S E R V I C E N O T E

**HP 4991A LanProbe**

**Modification to fix "Node Movement, or Node Hopping," and Network performance (throughput) problem.**

DATE: 07 January 1992

Pictorial: 4991A Rear right corner

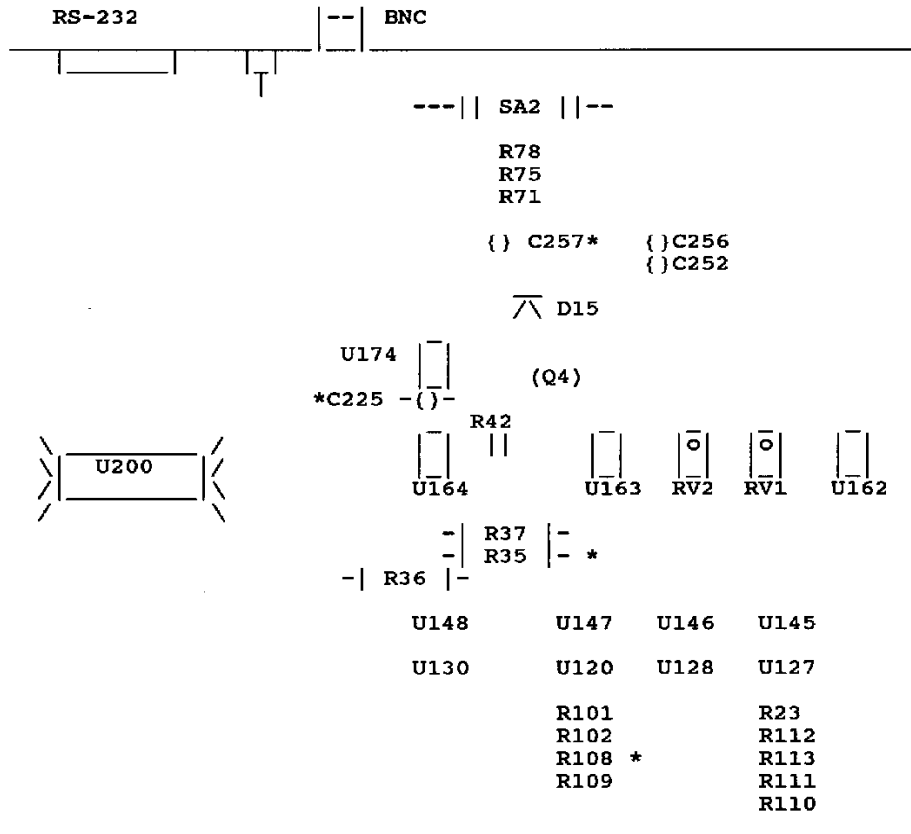
\*\* Board numbers 04991-69511/69511 could be rev. D or E. The board must match the pictorial diagram below before modification. If it does not match-DO NOT MODIFY.

The modification is to lower the echo pulse amplitude and to modify the HP4991A amplifier to accept the new pulse which will not affect the network performance.

Revision E boards have U200 heat sink. Rev. D boards DO NOT have the heat sink, it has a CHS1209 device.

1. Locate C225, remove and install new C225 0160-7175 4700pf.
2. Locate C257, remove and install new C257 0160-7172 1000pf.
3. Locate R108 (10Kohm) and replace with new 0757-0290 6.19Kohms.
4. Locate R35 and remove.
5. Locate U164 and cut pin 7 at IC body (ensure no continuity).
6. Affix label 04991-84337 "04991-66510" if working on a 04991-66510 board, or use label 04991-84338 "04991-66519" on 04991-66519 board. Note that the new date code is A-3149-38. Remove the old label before applying the new one.
